AGENDA

ST. TAMMANY PARISH PLANNING COMMISSION MEETING 6:00 PM - TUESDAY SEPTEMBER 8, 2020 ST. TAMMANY PARISH GOVERNMENT COMPLEX PARISH COUNCIL CHAMBERS 21490 KOOP DRIVE, MANDEVILLE, LOUISIANA

LAKESHORE VILLAGES (PHASE 11)

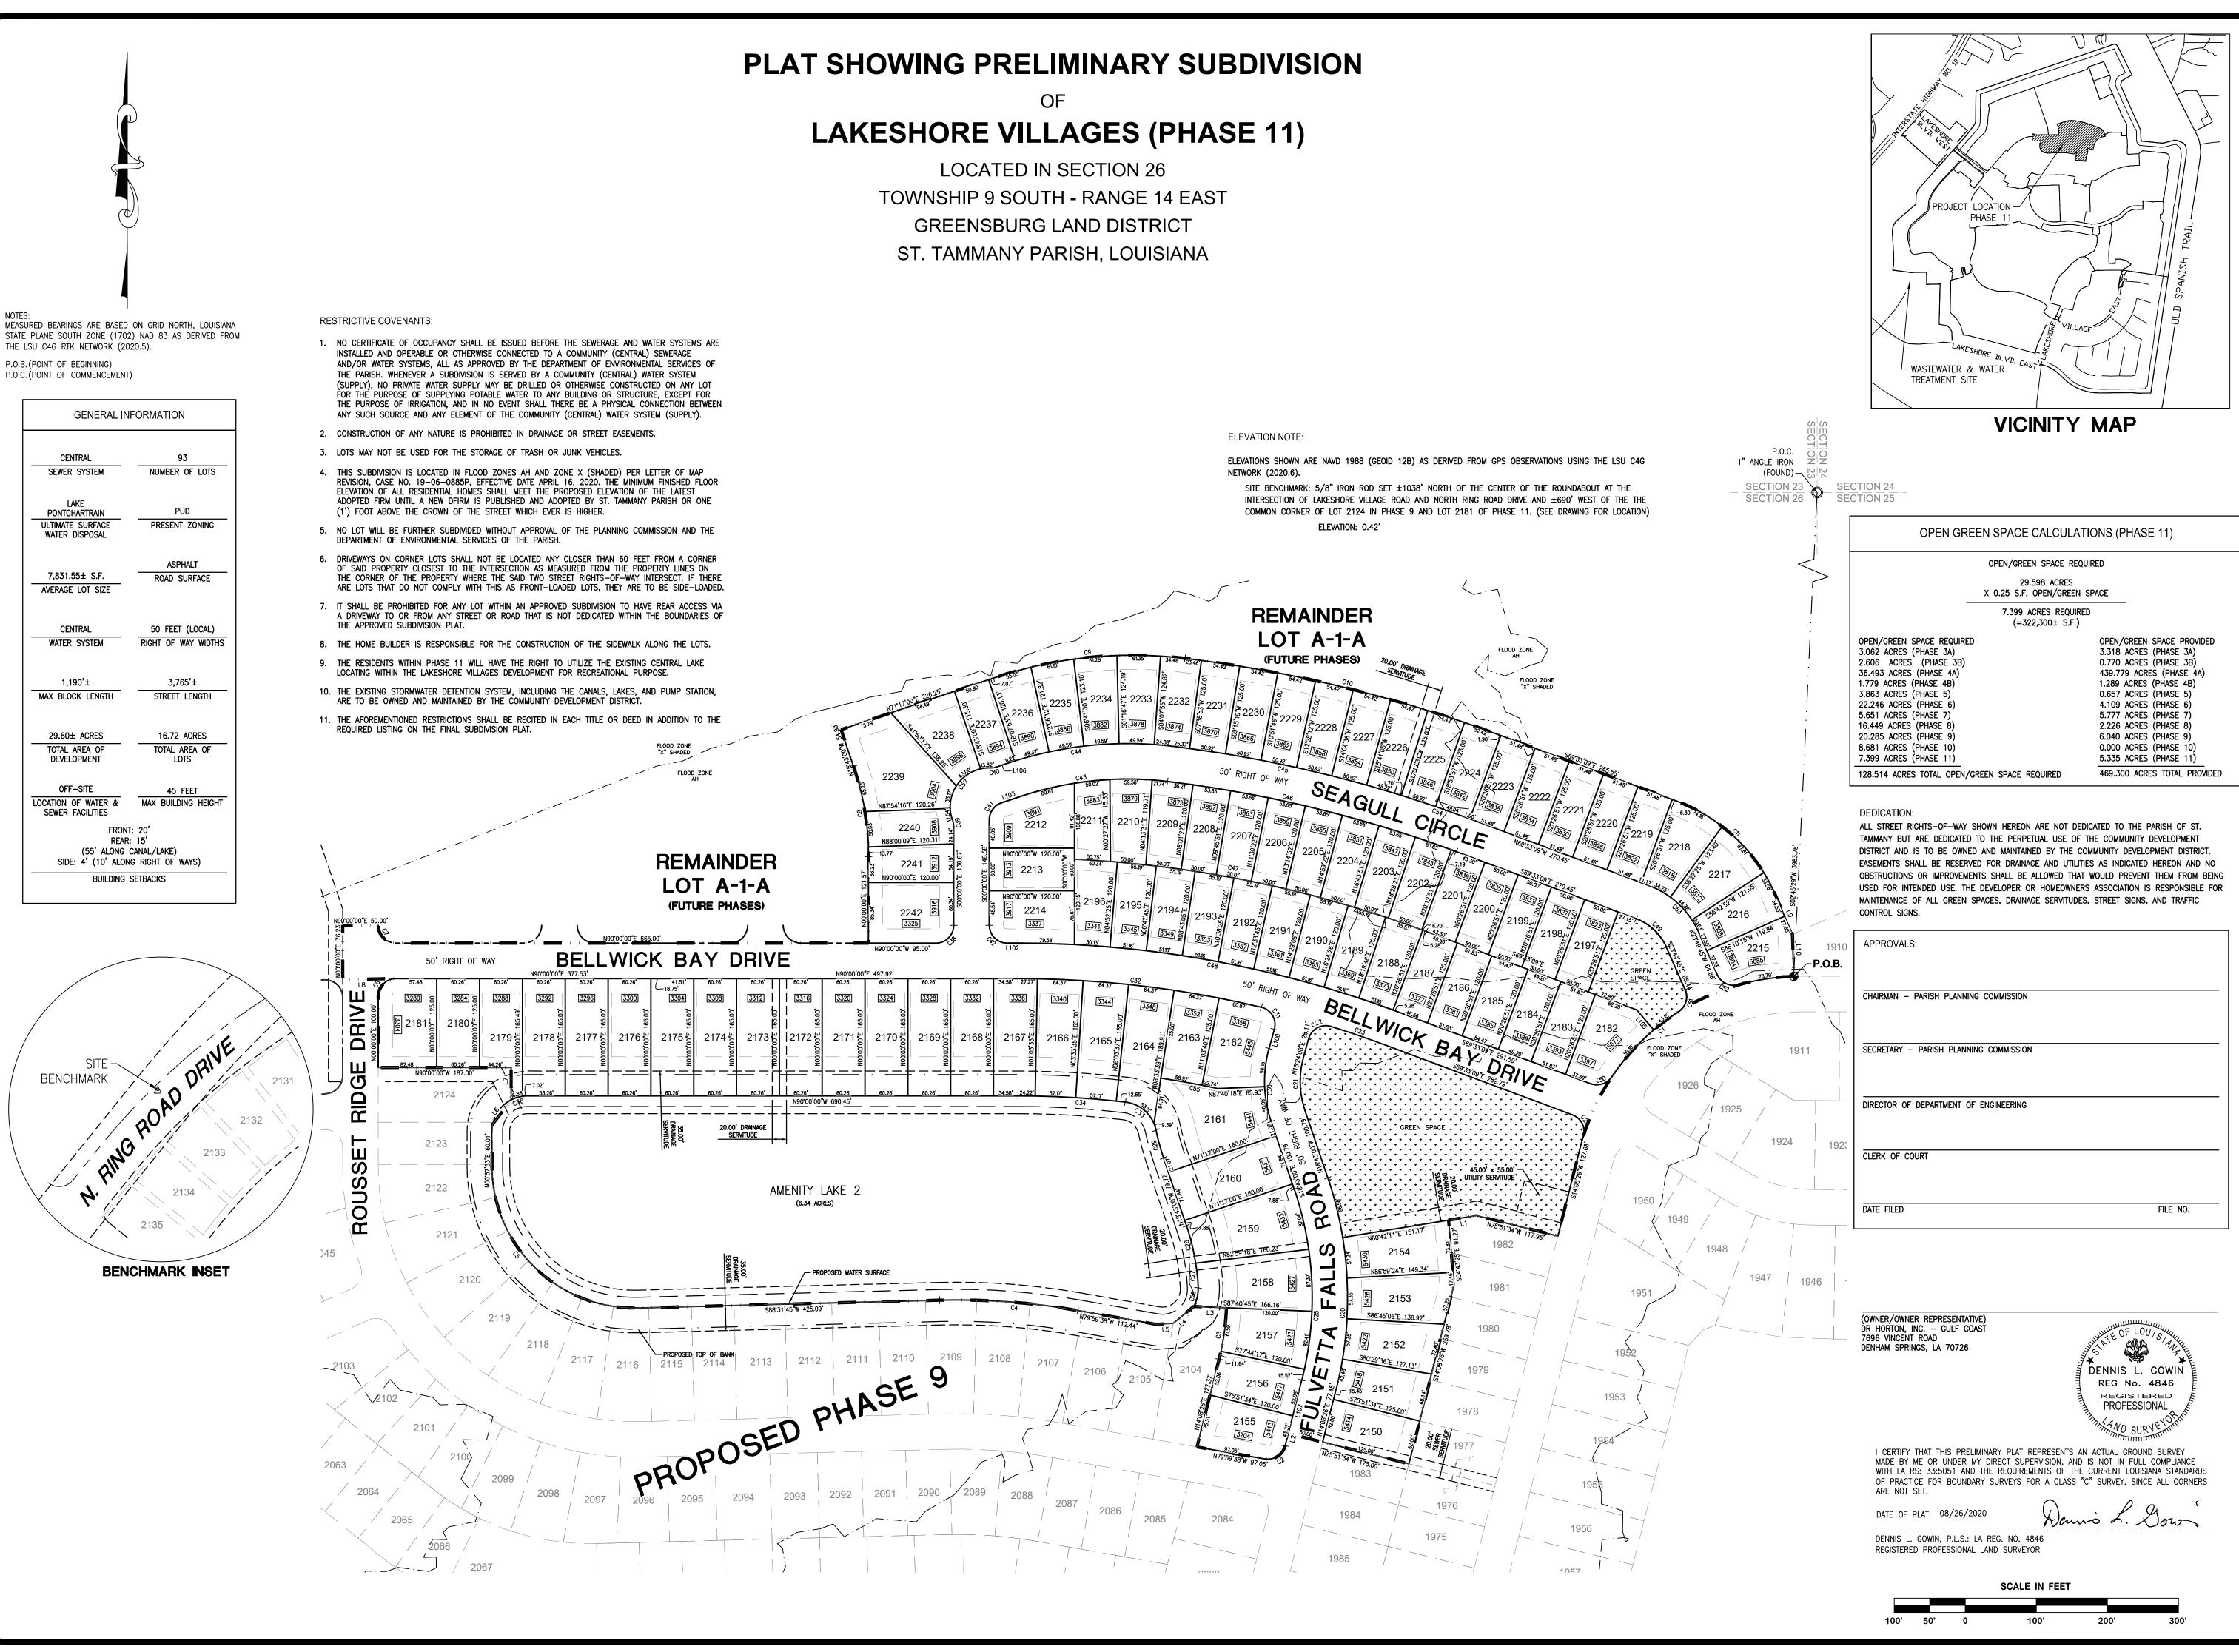
2. The asphalt dimensions in the pavement legends and roadway typical section have conflicting depths. Revise to eliminate this conflict. Be advised that at this time the request for a 3" asphalt section has not been approved and is still being evaluated for this phase.

- 3. The water and sewer plans need to be updated to ensure that the maximum spacing of 500' between fire hydrants is not exceeded. Revise fire hydrant locations accordingly.
- 4. Provide a water and sewer letter of capacity for this phase of Lakeshore Villages from Oak Harbor East Utilities.
- 5. Provide written plan approval from Oak Harbor East Utilities for this phase of Lakeshore Villages.

2020-2014-PP

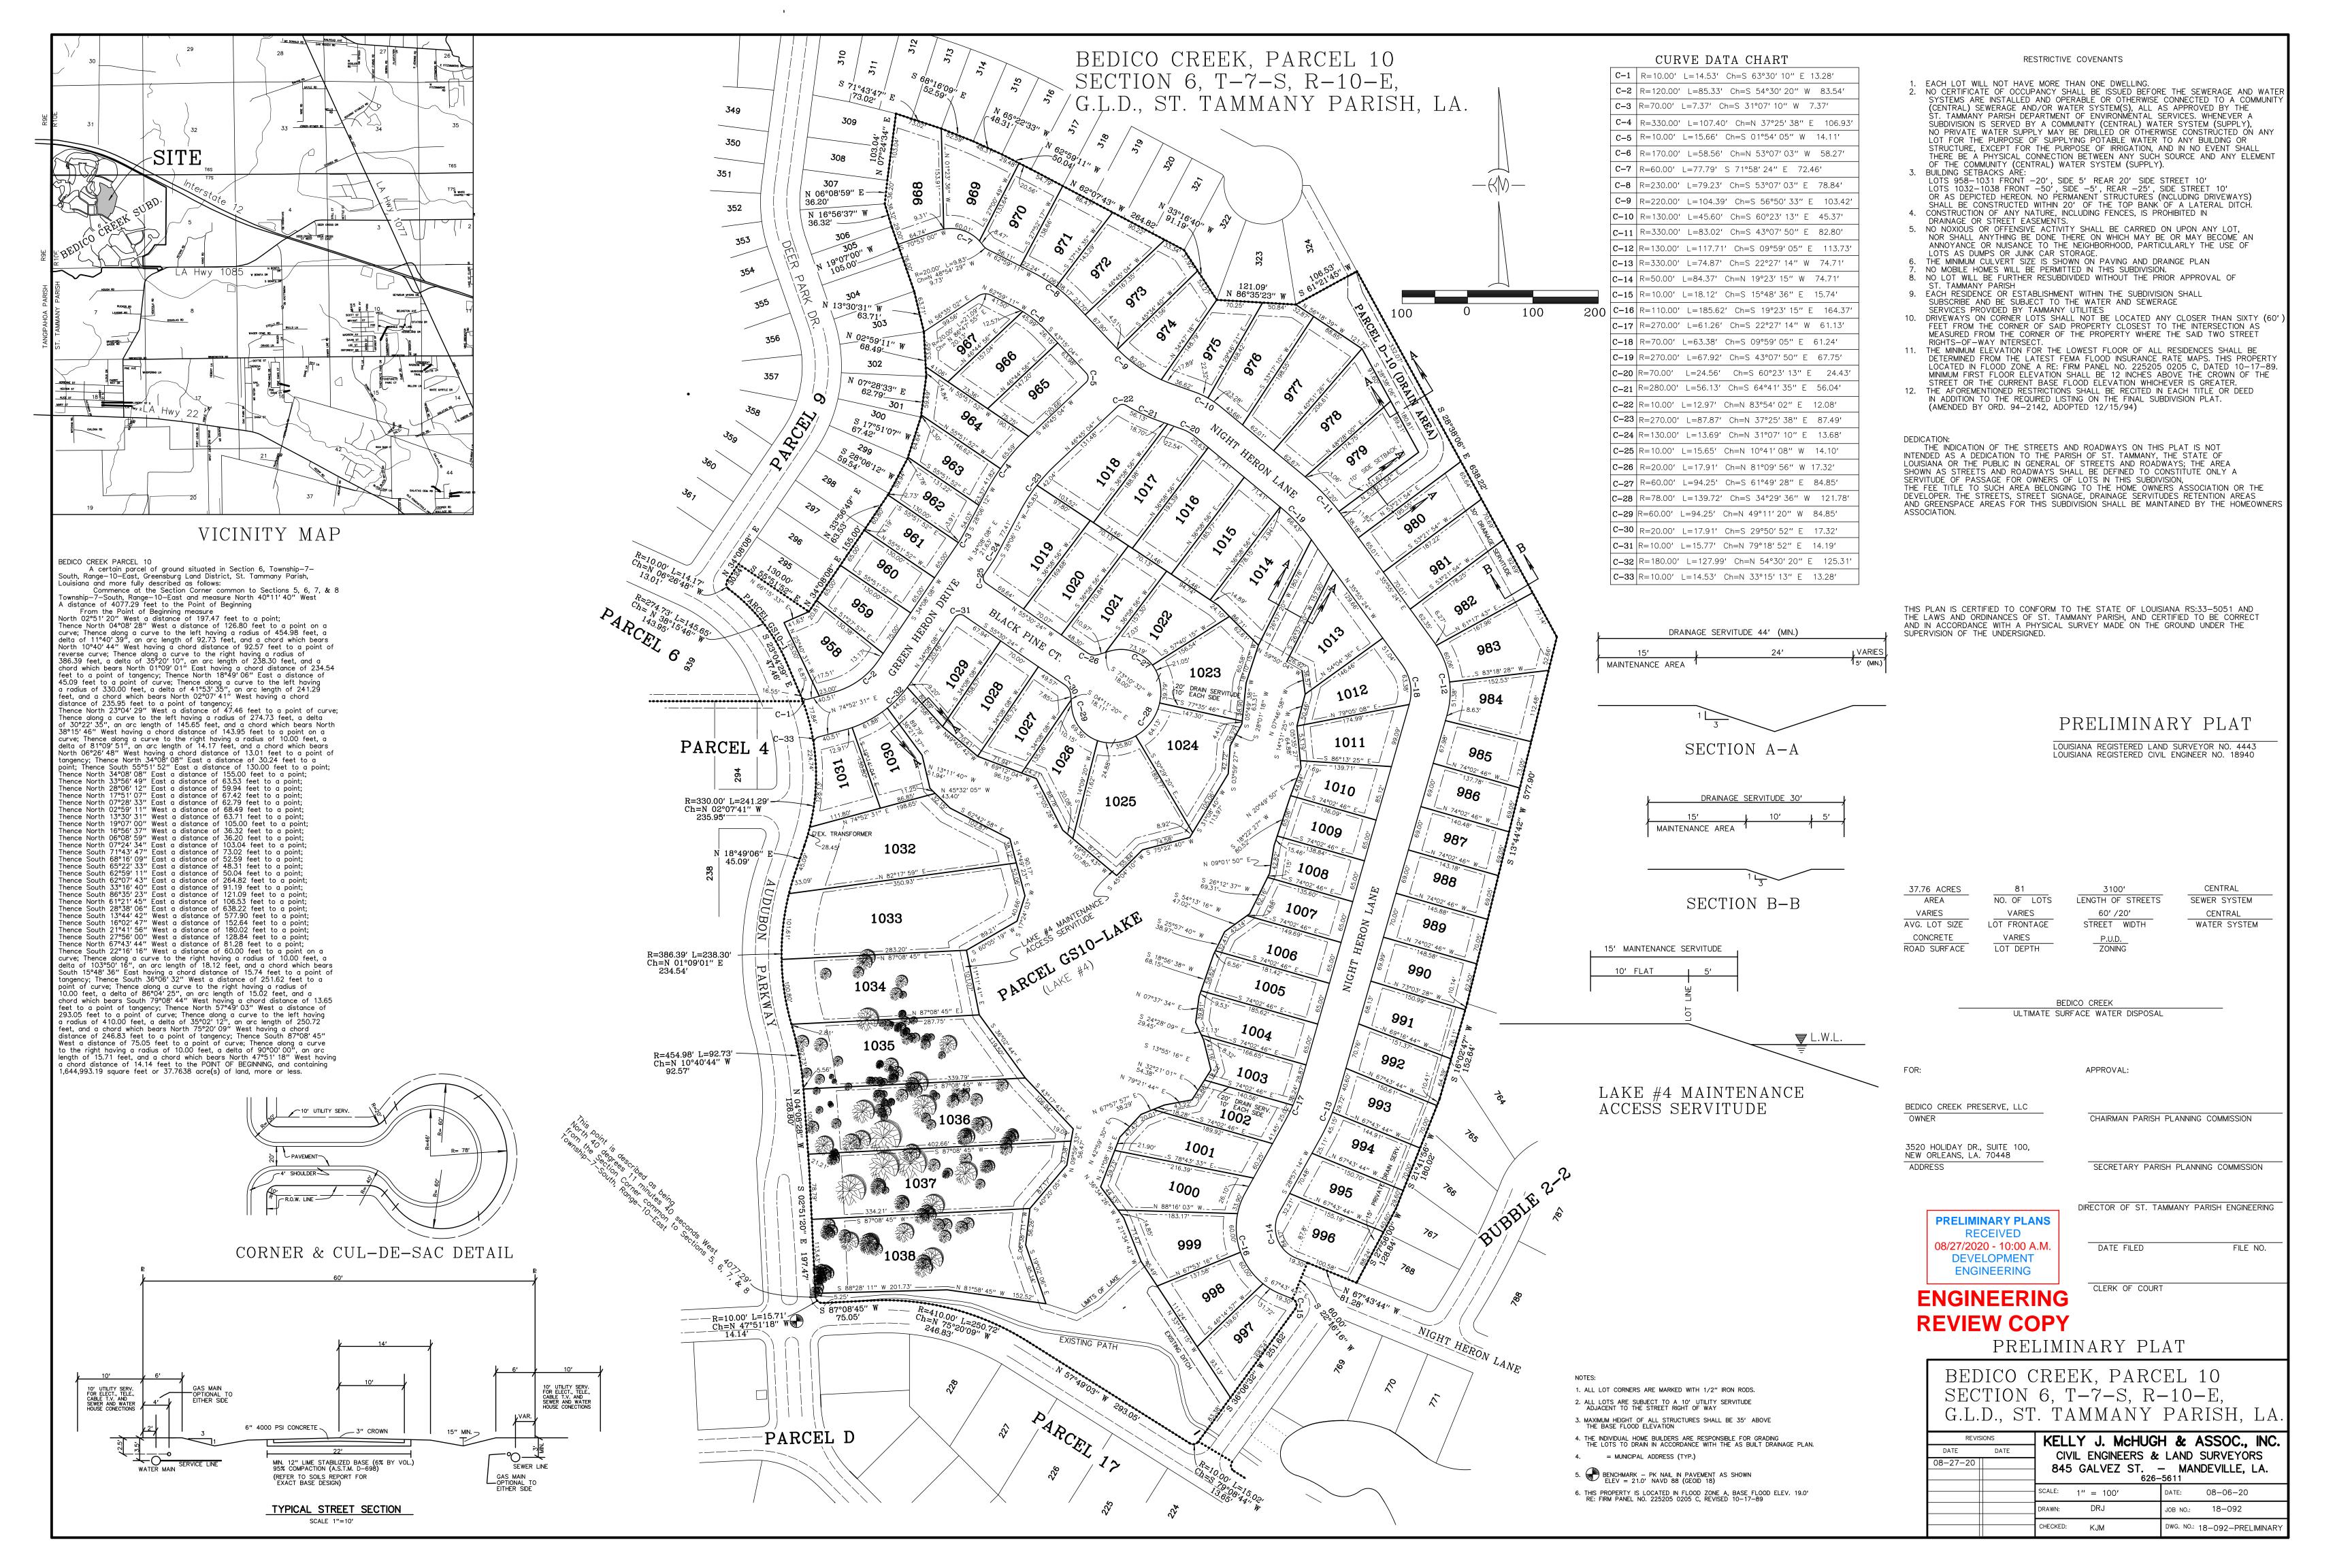
- 1. The Latest PUD plan states maximum allowable lot frontage is 90'. All lot conflicts need to be revised.
- 2. Revise servitude between Lots #979 & #980 on the Preliminary Plat to match the drainage servitude and ditch layout shown on the proposed Drainage Plan.

- 3. Provide profile drawings showing all centerline street grades and ditch bottom grades required for preliminary approval.
- 4. Provide multiple proposed cross sections including dimensions, elevations & side slopes for Lake #4 through the abutting lots.

Applicant must submit a revised PUD plan to the Planning Department showing an update to Bubble #3.
